Indicative Generation Capacity Expansion Plan (IGCEP) 2047

A Critical Review

COMMENTS ON INDICATIVE GENERATION CAPACITY EXPANSION PLAN (IGCEP) 2047

Figure 1-Thar coal displaces hydropower

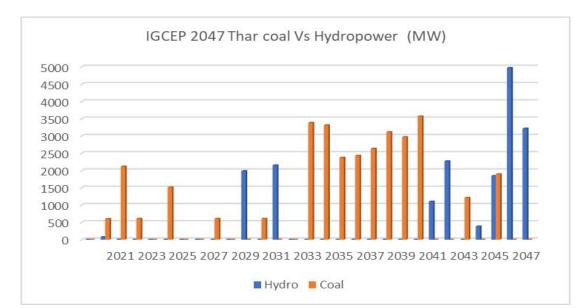
Figure 1 shows Thar coal addition displacing hydropower (IGCEP 2047)

From Figure 1-2 we can see that hydropower capacity has been pushed to one side; and visually we would expect to see much more blue spread across the IGCEP 2047 plan horizon!

Figure 2- Thar coal and ARE's displace hydropower

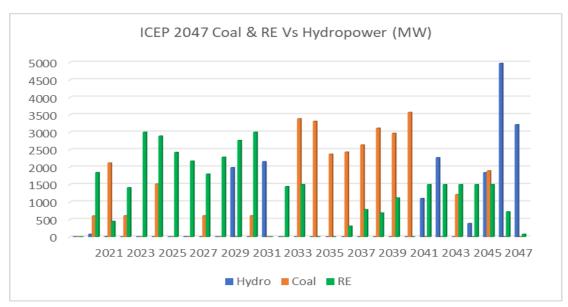
Figure 2 shows that coal and renewables are pushing out hydropower (IGCEP 2047)
